OBSERVATION

Crumhach Wind Farm, Co. Sligo

An Coimisiún Pleanála Case PAX21.324561

Re: Case PAX21.324561 – Proposed Crumhach Wind Farm, Co. Sligo

Figure C1. OPW Floodinfo.ie – Dromore West area, High-end Future Scenario.

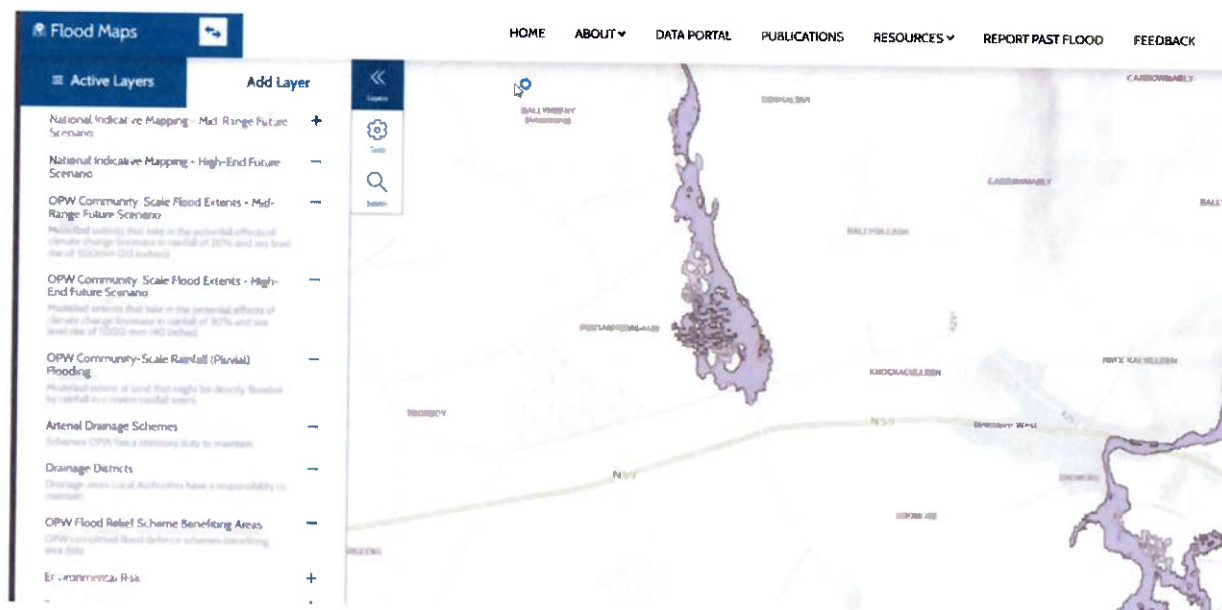
Relevance to Location 17. The mapping reinforces the request for a Location 17-specific hydraulic assessment of the existing roadside drain before the proposed overrun hardstand preparation, temporary runover area, vegetation clearance or any associated changes to verge/ground levels are undertaken. The assessment should demonstrate that the works will not reduce drainage capacity, impede flood conveyance or redirect runoff towards the adjoining dwelling.

Applicant drawing WCH-CVL-SK-0011-04, Sheet 004 of 007 – Turbine Delivery Route, Location 17.

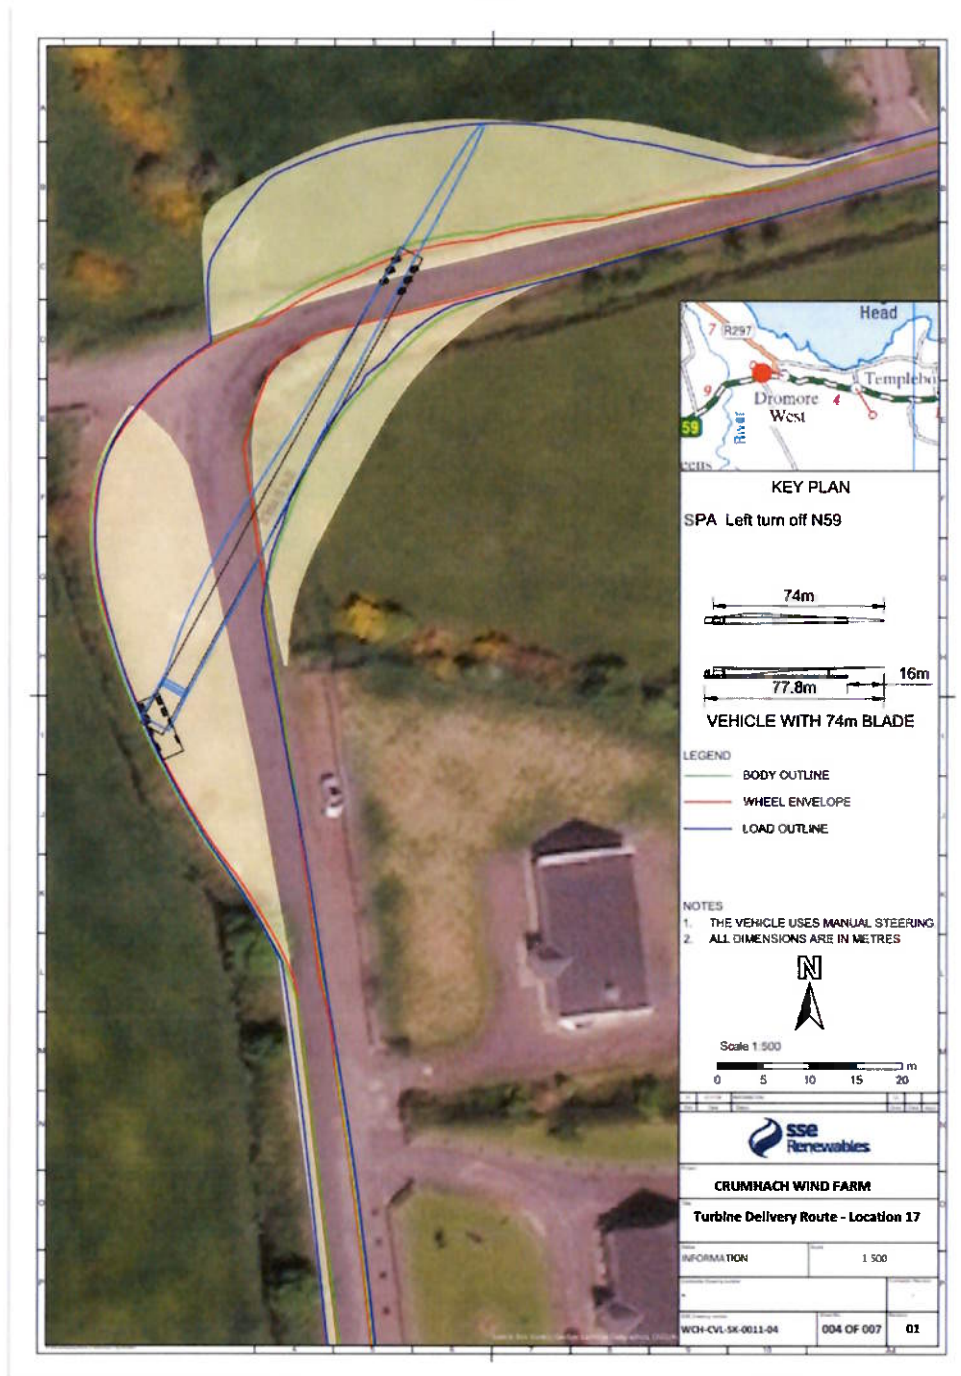
- The final relationship between the wheel/body/load envelopes and our registered folio boundary has not been demonstrated on a survey-grade cadastral overlay.

The dedicated Autotrack drawing, WCH-CVL-SK-0011-04, Sheet 004 of 007, is titled "Turbine Delivery Route – Location 17". It models a manually steered vehicle carrying a 74m blade, with a stated vehicle/load length of approximately 77.8 m. Separate wheel, vehicle body and load/blade envelopes are shown. We request that the Commission assess the

The available drawings do not provide a survey-grade combined plan showing the registered folio boundary, public road boundary, land controlled by the applicant, and the complete wheel, body and turbine blade/load envelopes. Our property immediately adjoins Location 17 junction and a small parcel understood to be controlled by SSE for the current project.

We request a survey-grade cadastral/CAD overlay prepared from a current site survey, showing our registered folio boundary and stone boundary wall together with the public road boundary, all applicant-controlled land, complete wheel envelope, vehicle body envelope, blade/load envelope, visibility splays, hedgerow/vegetation removal, overrun/runover works and all temporary construction limits. The drawing should expressly confirm whether any part of the vehicle, load/oversail or physical work enters, oversails, undermines or otherwise affects our registered property. We do not allege encroachment on the basis of the presently available drawings; we ask that the applicant demonstrate the position accurately.

Figure F1 – Aerial image annotated by the observer to show the approximate locations of existing drains and culverts at Location 17

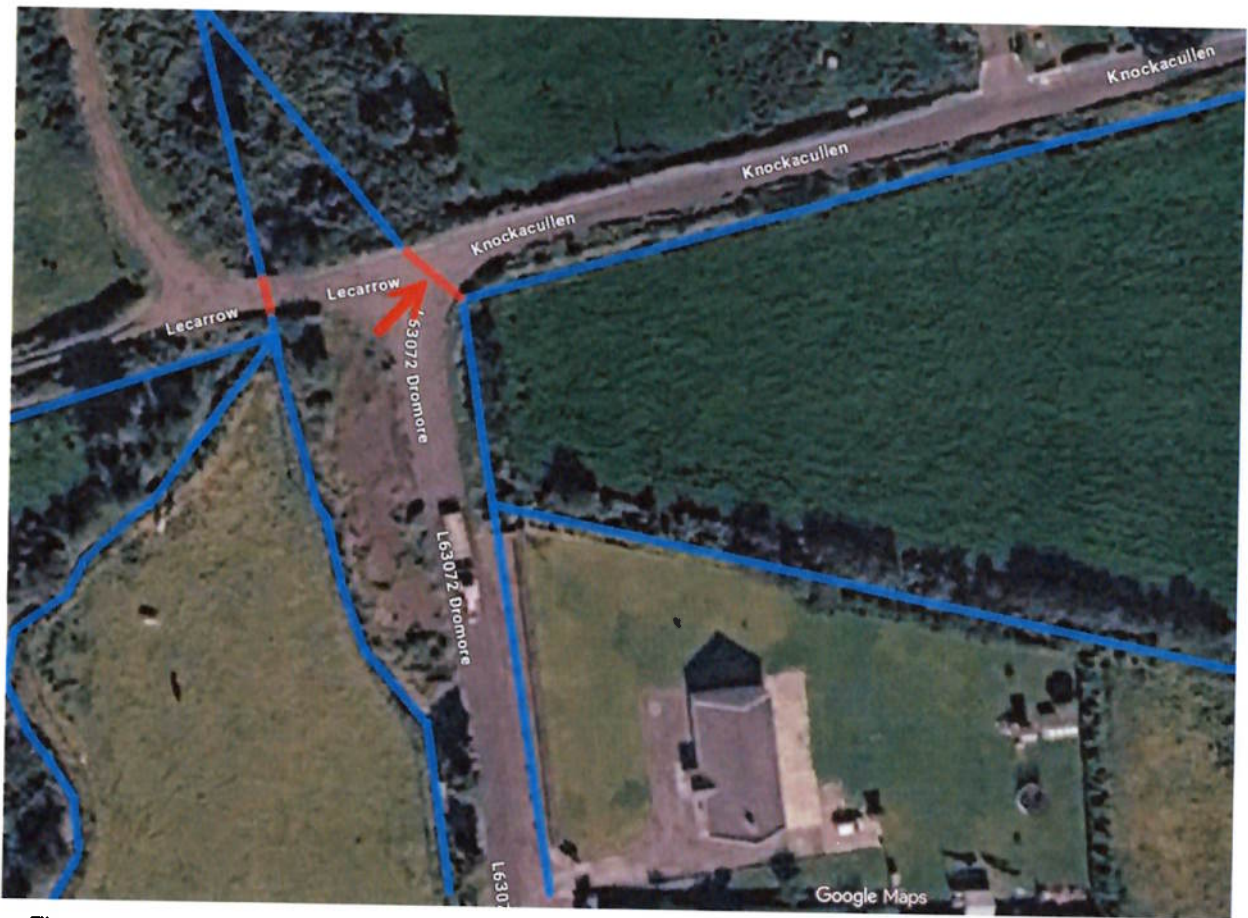
There is also an existing stone-built culvert/drain passing beneath the public road in the immediate Location 17 area and forming part of the local drainage network (see Appendix F). The observer's annotated aerial image indicates its approximate location; the annotation is not survey-grade. The Applicant's Location 17 Autotrack drawing shows the wheel, vehicle-body and blade/load swept envelopes but does not identify this culvert. We have not identified in the submitted Autotrack or drainage drawings an assessment establishing its precise position, construction, dimensions, depth of cover, structural condition or load-bearing capacity relative to the proposed abnormal-load wheel/axle loading. This is notable because the Applicant's Autotrack documentation expressly identifies a "STONE CULVET" at another turbine-delivery-route location (Location 19).

- A surveyed structural and hydraulic assessment of the existing stone culvert beneath the road at Location 17, showing its exact position relative to the Autotrack wheel envelope, its dimensions, construction, condition and depth of cover, together with the proposed transporter wheel/axle loads and engineering verification that the structure can safely accommodate the proposed abnormal-load movements without structural damage, settlement or reduction in hydraulic capacity.

The Applicant's Location 17 Autotrack drawing shows the wheel, body and load envelopes for the proposed turbine delivery vehicle but does not identify the existing stone culvert shown approximately by the observer on this image. The Applicant's Autotrack documentation does, however, expressly identify a "STONE CULVET" at another turbine-delivery-route location (Location 19).

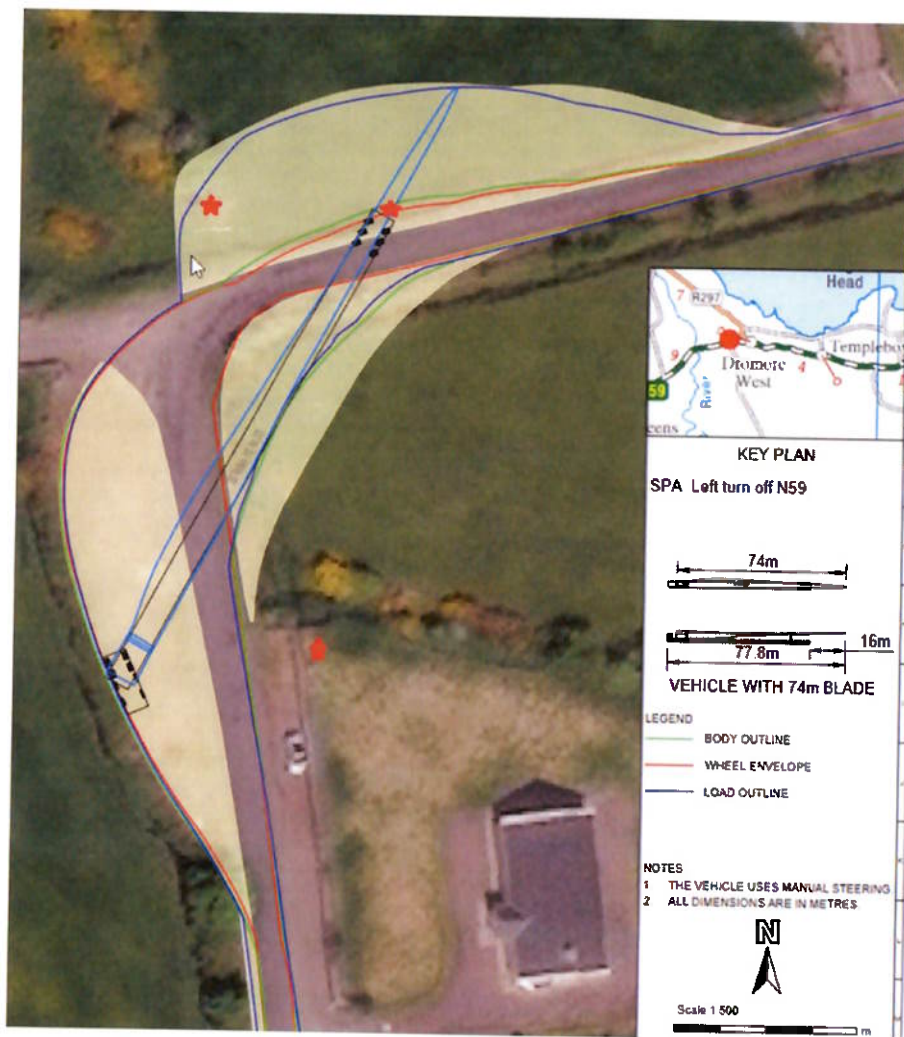
Existing electricity and telecommunications poles and associated overhead services are located immediately alongside the turbine delivery route at Location 17. Comparison of the Applicant's Appendix 15-3 Autotrack drawing with Street View imagery indicates that at least one existing electricity pole and a telecommunications pole may lie within or very close to the area swept by the 74 m blade/load envelope. Please refer to Appendix G, where we have marked the approximate positions of the visible poles on a copy of the Applicant's drawing for illustrative purposes. These markings are not survey-grade and are not relied upon as proof of the precise position of the poles; rather, they identify an apparent physical conflict which is not resolved by the submitted Location 17 drawing.

This issue has a direct potential consequence for our property. The electricity pole which appears from the illustrative comparison to lie within the blade/load swept envelope forms part of the overhead electricity connection serving our dwelling, with the electricity line continuing from this pole towards the pole immediately beside our property.

The illustrative comparison indicates a potential conflict between existing roadside utility infrastructure and the Applicant's blade/load swept envelope. Because the observer-added pole positions are approximate and are not survey-grade, this appendix does not assert that a collision or interference has been established. It illustrates why the survey-grade assessment requested in Section 12A is required.

We therefore request that the Applicant be required to provide a survey-grade Location 17 drawing showing the precise position of all existing electricity and telecommunications poles, associated overhead services and other fixed roadside infrastructure together with the complete wheel, vehicle-body and blade/load envelopes, and to demonstrate the required clearance. If any pole, electricity line or telecommunications infrastructure requires temporary or permanent removal, relocation, protection, disconnection or alteration to
